June 12, 2025
Updated June 17, 2025
ES-9607.02

Derek and Eileen Cheshire
7615 East Mercer Way
Mercer Island, Washington 98040

**Subject: Response to Review Comments
Cheshire Property
7615 East Mercer Way
Mercer Island, Washington**

Subsurface Exploration Plan
 Cheshire Property
 Mercer Island, Washington

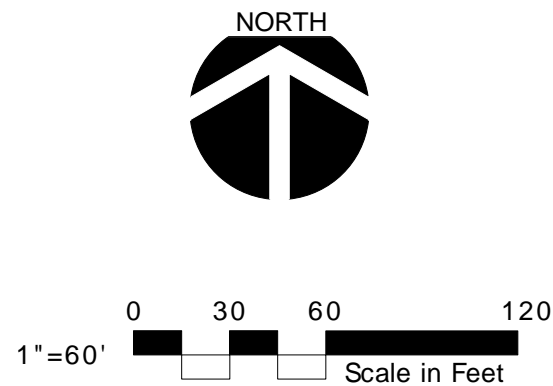
2. *Please provide a scaled site plan with elevation contours showing the boring locations.*

Attached.

ES-9607.01
Cheshire SFR
Static Condition

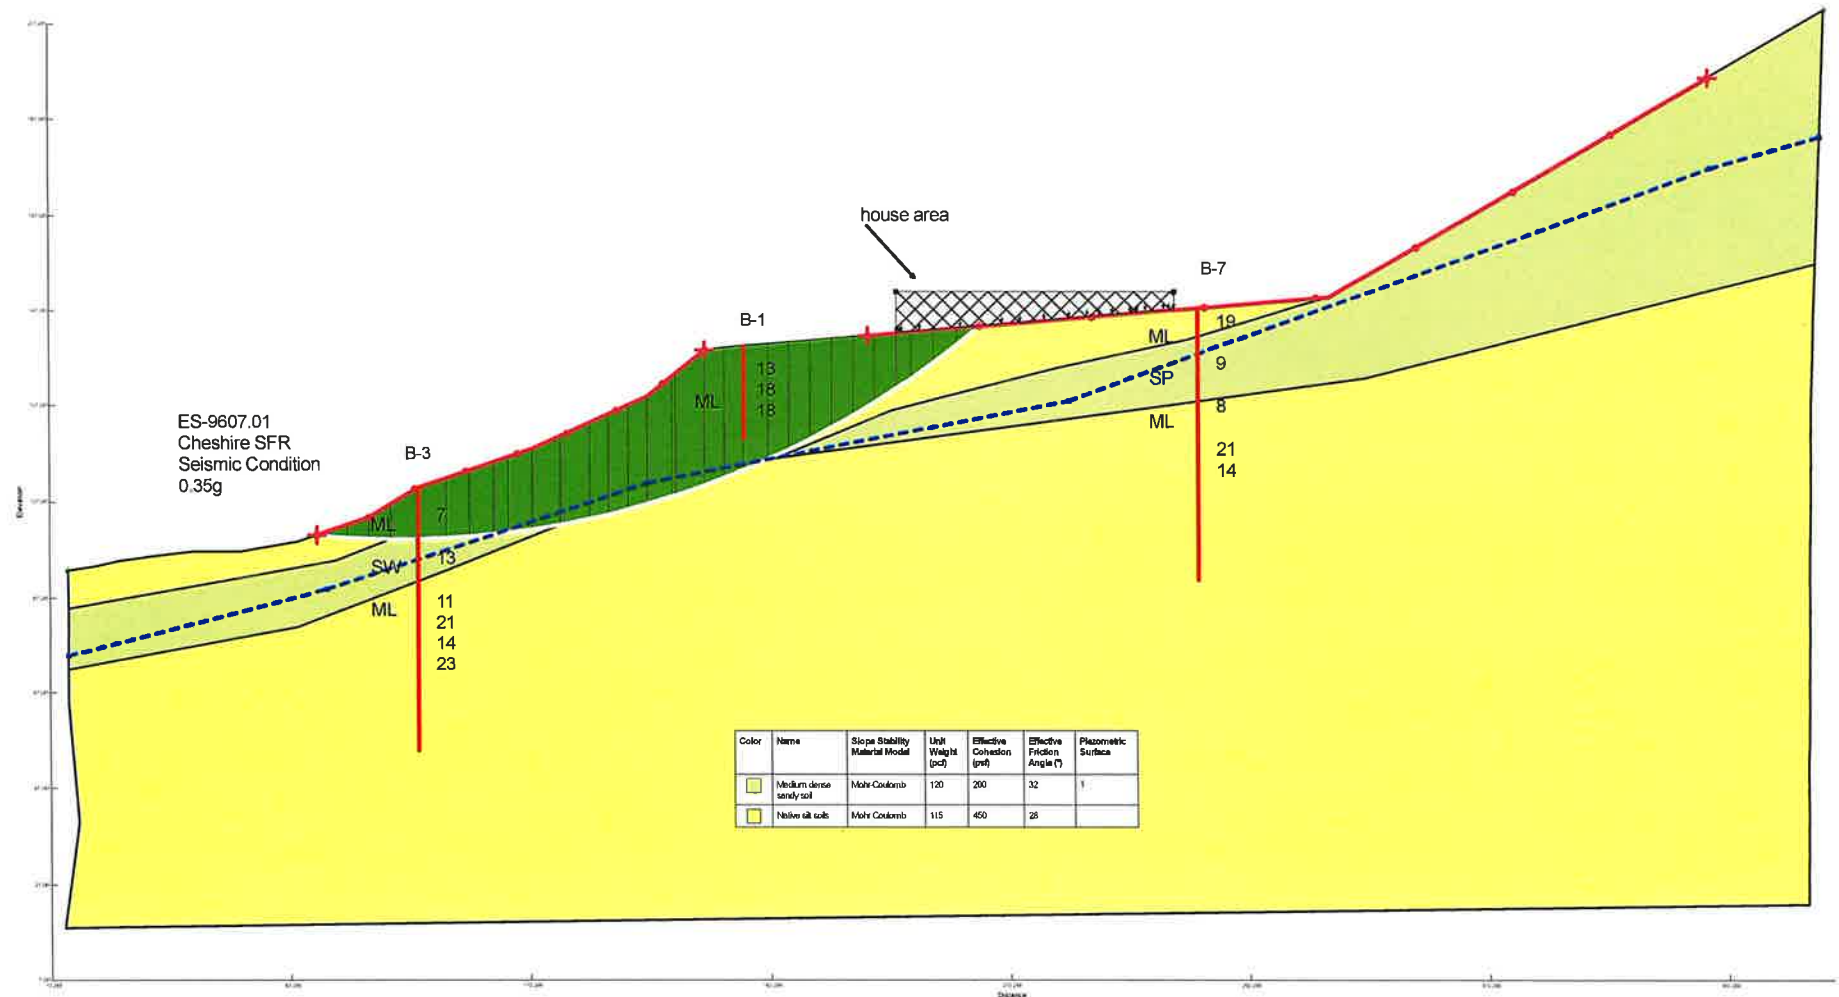
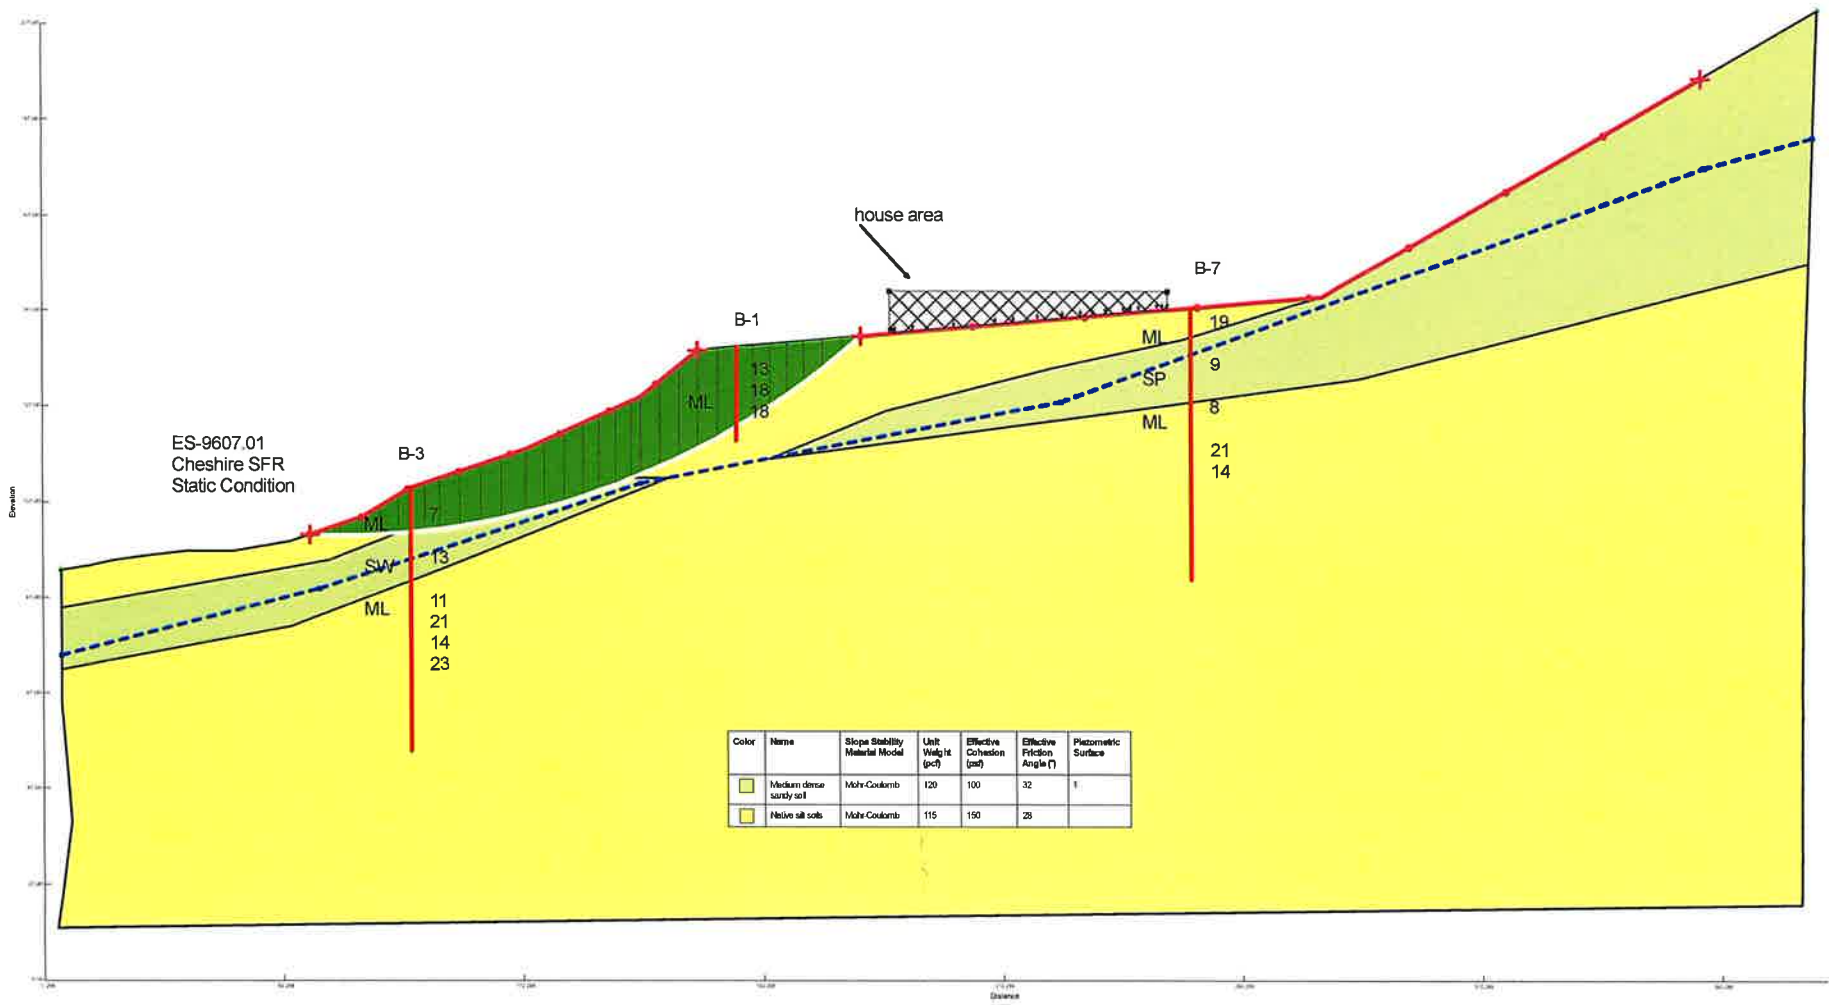
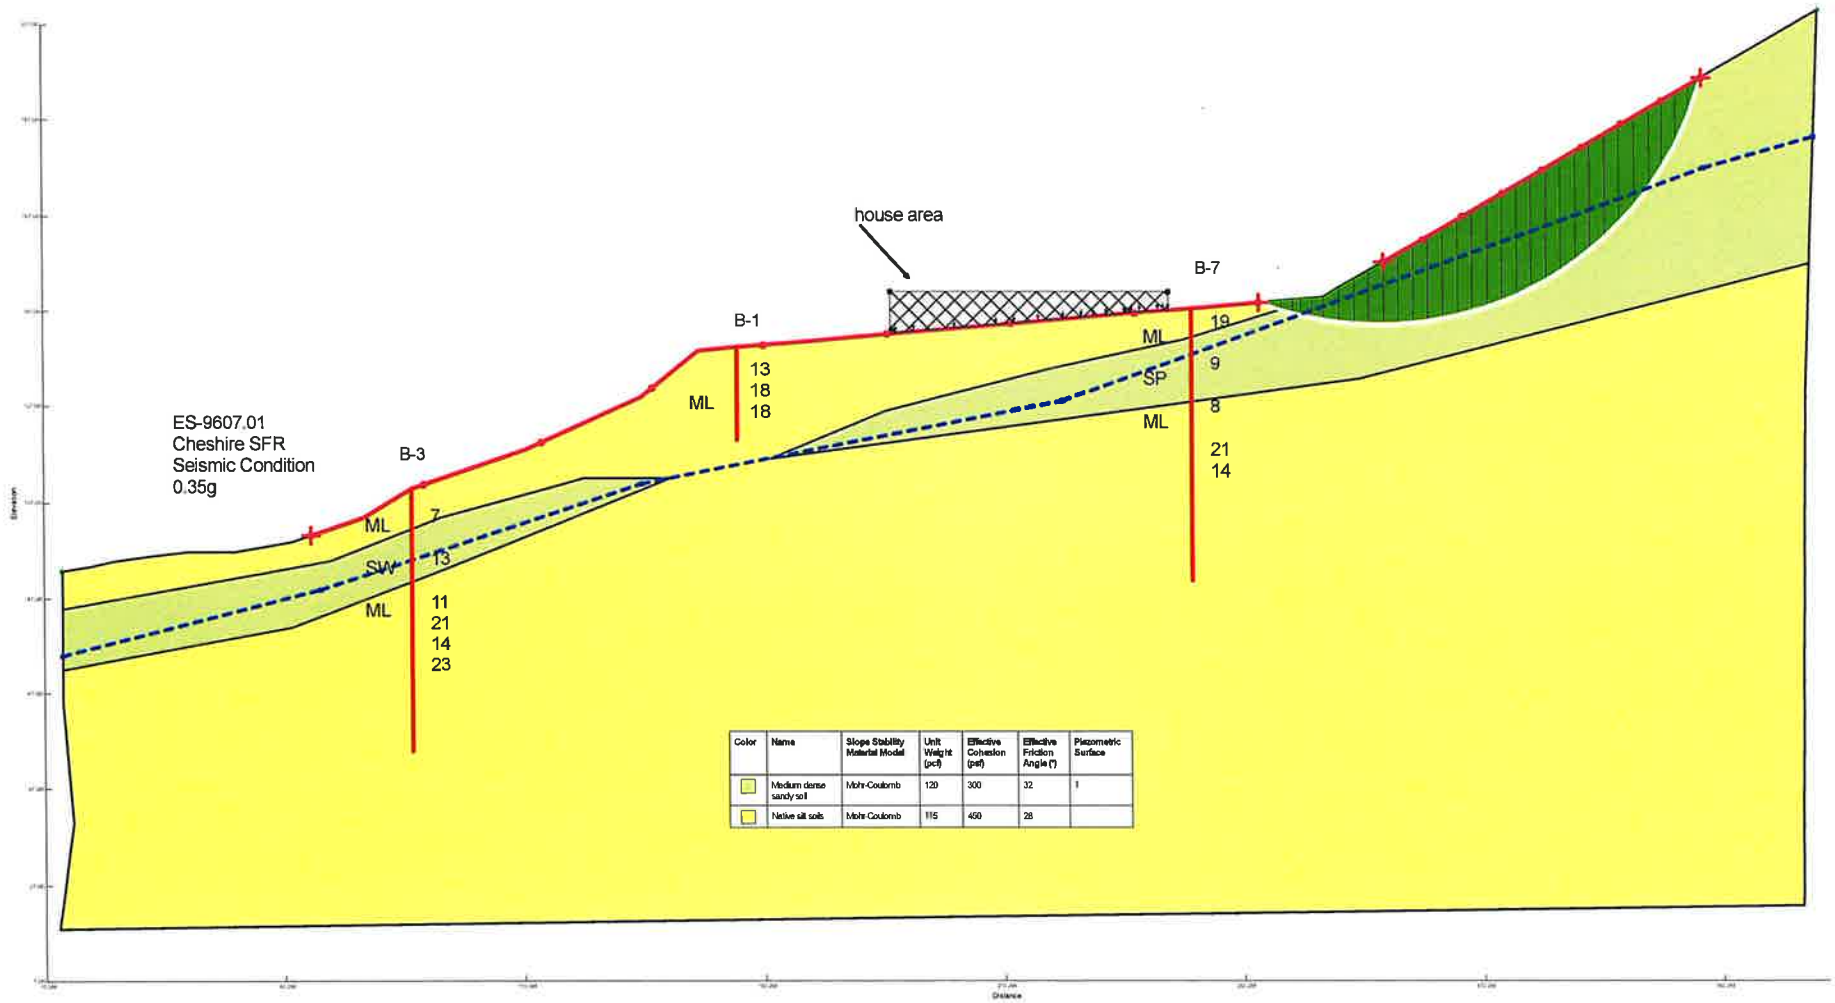
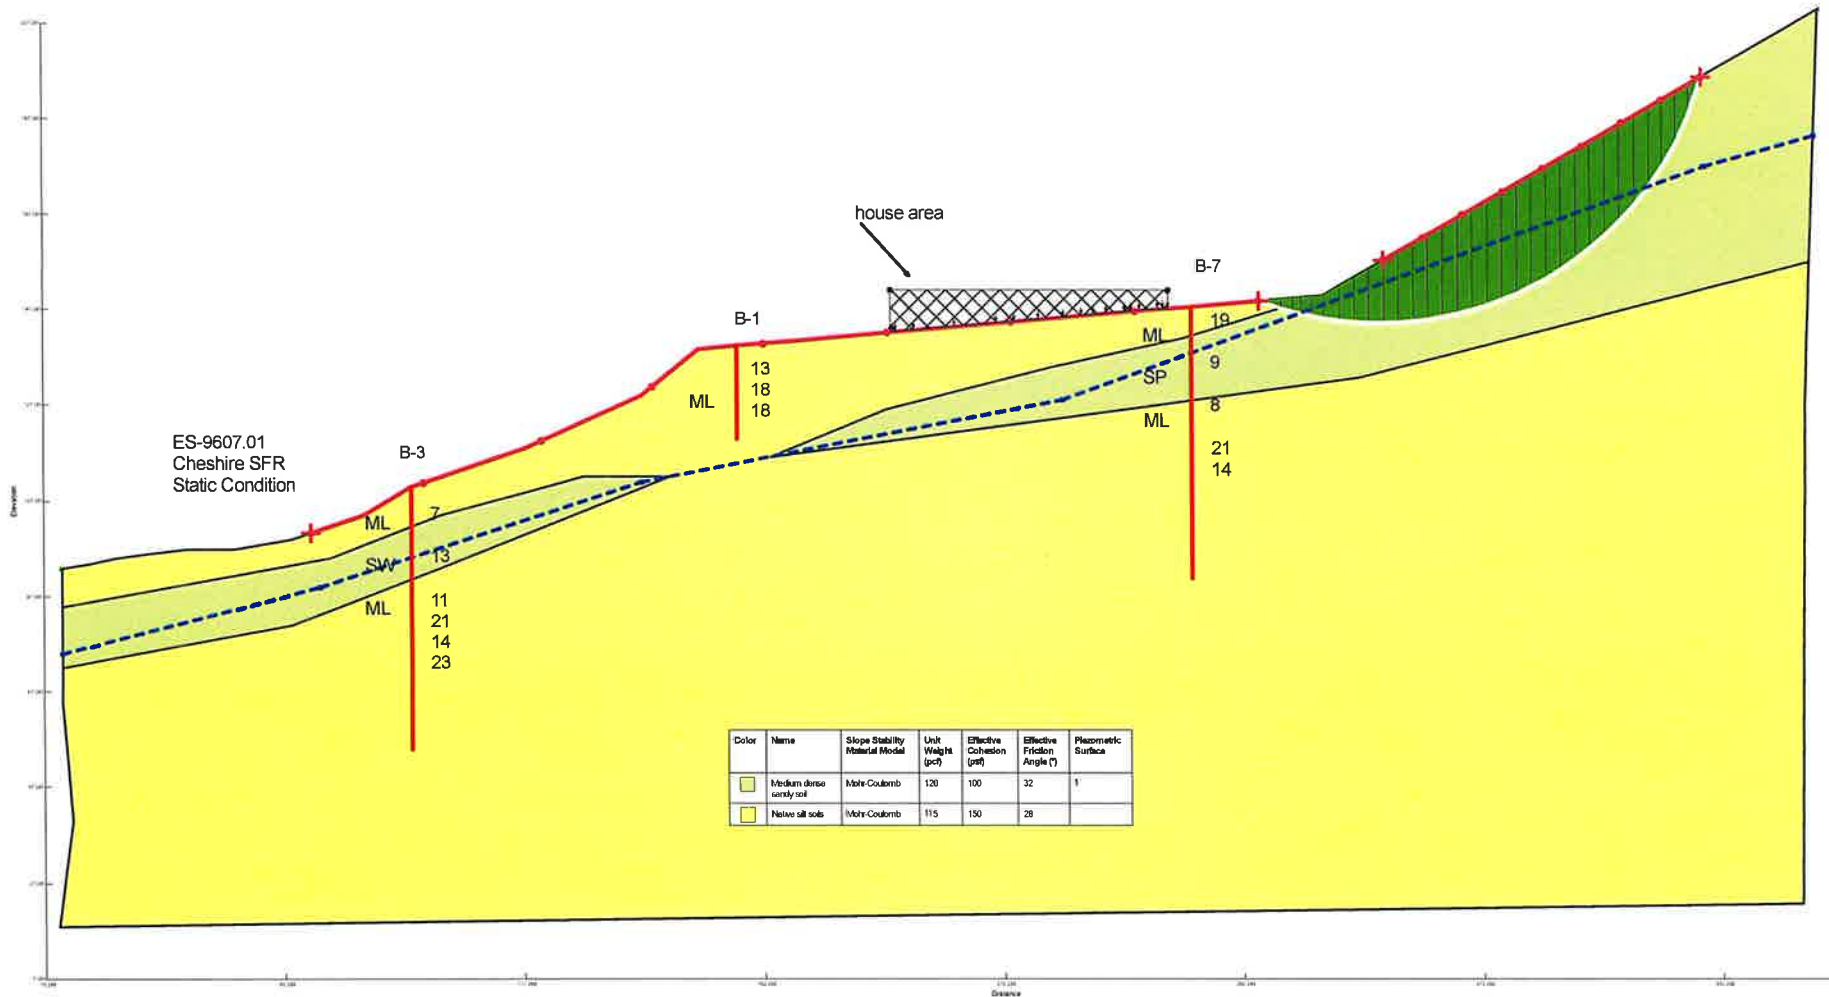
4. *Please provide a slope stability assessment of the entire site (including the slope west of the residence) under static and seismic loading conditions.*

Please include the computer printout of all the results of the slope stability analyses. Appendix B of the geotechnical report was not included in the submitted report.

- 6. Please show on the slope stability cross-sections the locations and subsurface information (SPT, soil type and groundwater condition) of the borings used to generate the stratigraphy shown on the sections. Please provide discussion on the stratigraphic changes from one section to another and how the groundwater level was determined across the sections.*

Included as an attachment to this response letter.

Requested information included in updated SlopeW output attached. We updated the soil layers to include additional saturated sandy layers. This analysis does not account for the gradation between layers and related 'fabric' of the soil underlying this site. With respect to groundwater, while the soil logs report groundwater, it is not within a consistent layer or zone on this site, rather, it's reported within the sandier deposits that vary across the slope. The updated SlopeW analysis applies a groundwater condition under the entire slope. Comparing the updated SlopeW analysis to the version previously submitted, it appears that minimum factor of safety (FOS) values are relatively consistent and suggest that, while there may be isolated areas of instability, such as within the slope to the west, global site stability does not pose an increased threat to the property. We applied a relatively thick layer of silty sand soil to the western slope, as a conservative approach given the limited amount of subsurface data. We expect much of the core of this slope to be comprised of dense/hard silt deposits. The slope stability modeling focused on the soil and groundwater conditions under the proposed building. It is acknowledged that soil, groundwater and terrain vary across this site, including the existing DADU. On this basis, in our opinion, the overall stability of the site is acceptable from a geotechnical standpoint. This analysis further supports the use of a structural fill mat and woven geotextile under new foundations, that will provide a uniform support and help reduce the potential for differential settlement that may cause the building to collapse. As is standard for any site located on a slope, should a maximum credible earthquake event occur and trigger movement, the goal is to prevent structural collapse, while acknowledging that severe damage to the overall site may occur. This is supported by the age of the existing building that was subjected to the Nisqually earthquake in 2001 and shows little to no signs of obvious foundation settlement or displacement. The recommended foundation support approach will provide a significantly more robust and resilient support system for the new building.

LIQUEFACTION ANALYSIS

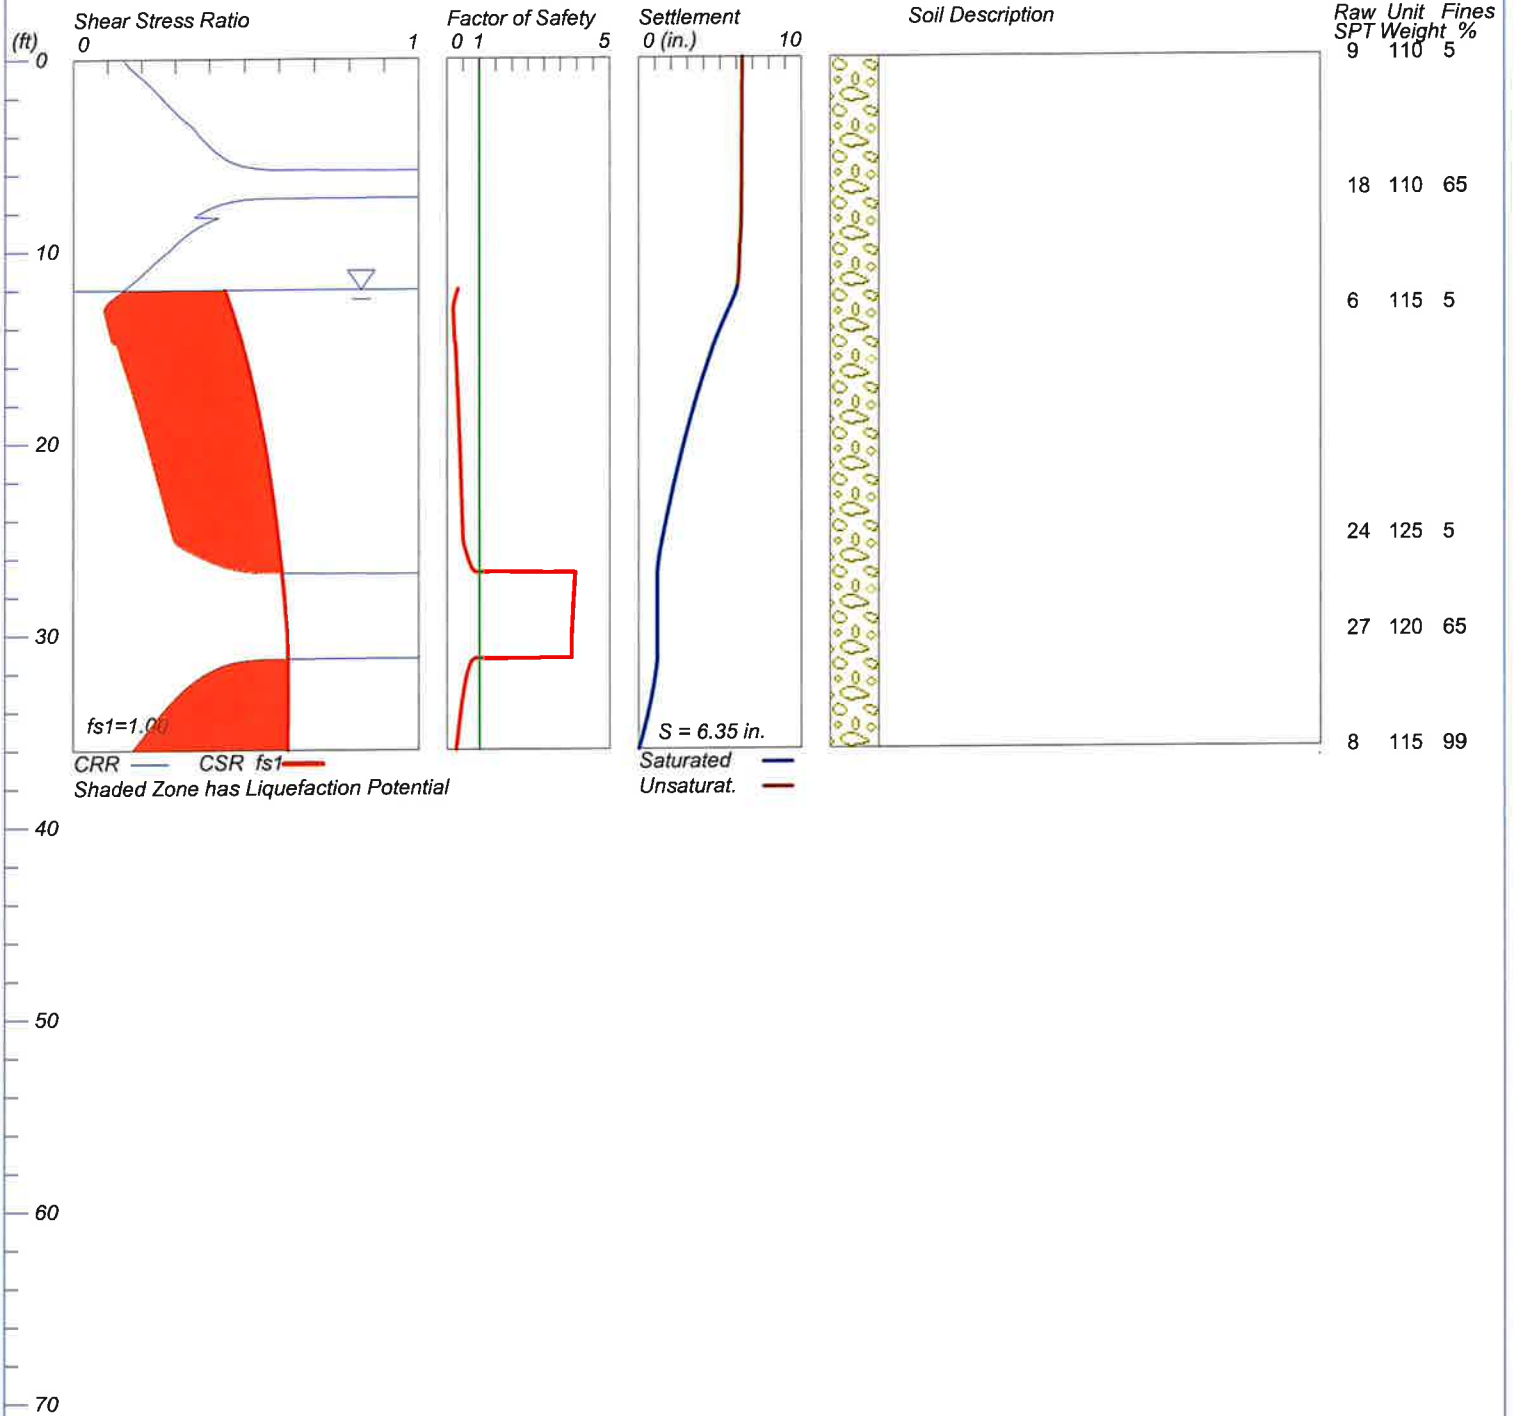
9. *Please assess the potential for liquefaction at the site and estimate post- liquefaction settlement, lateral spreading or flow failures as required by IBC using a peak ground acceleration associated with a 2% probability of exceedance in 50 years earthquake. Please include liquefaction assessment calculations, any post- liquefaction settlement calculations, residual strength determinations and associated stability analyses and/or lateral deformation calculations for review.*

Included as an attachment. The groundwater conditions on this slope are highly variable and discontinuous, as are the soil gradations. In this respect, while saturated clean sandy soils that are loose may liquefy, the extent of this phenomenon is expected to be discontinuous across the site and may not adversely impact the overall site response as the estimated magnitude suggests. Based on the soil variability on this site, we would expect the effects of liquefaction to be isolated and variable as well. Therefore, overall site or site global effects would likely be discontinuous.
